DESIGN CP	DRAWN BY CP	DART AEROSPACE LTD HAWKESBURY, ONTARIO, CANADA	
CHECKED #	APPROVED #	DRAWING NO. D3016	REV. A SHEET 1 OF 3
DATE 01.05.18		TITLE SEAT FRAME ASSEMBLY	SCALE NTS
A	01.05.18	NEW ISSUE

DRAWING NO. D3016	TITLE SEAT FRAME ASSEMBLY	REV. A	DART AEROSPACE LTD ENGINEERING ORDER	D.E.O. NO. D3016-A-1	SHEET NO. SHEET 1 OF 1	SCALE NTS
DRAWN 1	CHECKED UP	MFG. APPR. R	APPROVED WAP	DE APPR. W		
DATE 10.01.29	DATE 10.01.29	DATE 10.01.29	DATE 10.01.29	DATE 10.01.29

PURPOSE:

TO REVISE D3016-11 SADDLE'S HOLE SIZES

D3016-11 SADDLE

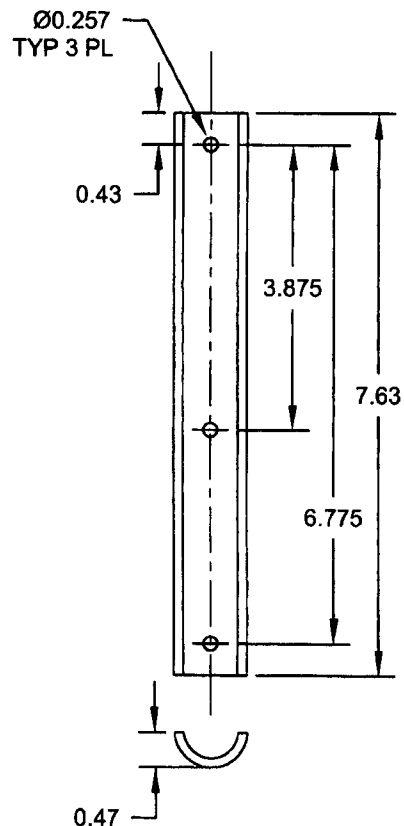
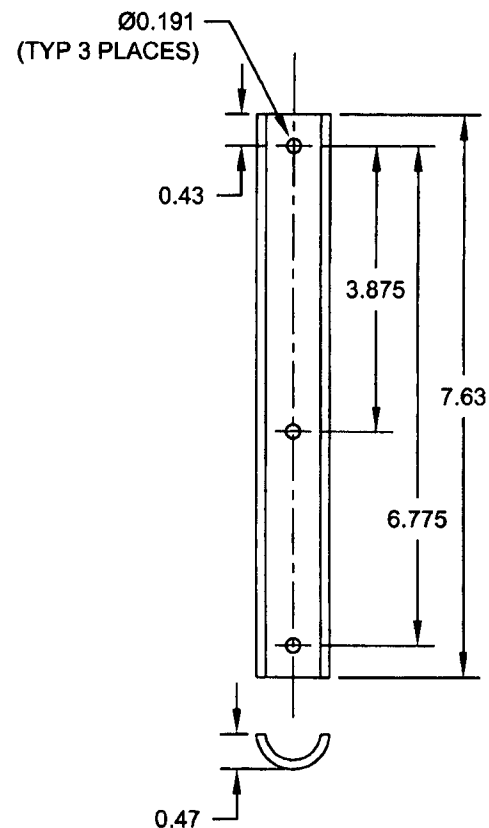
DETAIL D3016-11 SADDLE (SHEET 3): Ø0.257 TYP 3 PL WAS Ø0.191 (TYP 3 PLACES) AS SHOWN:
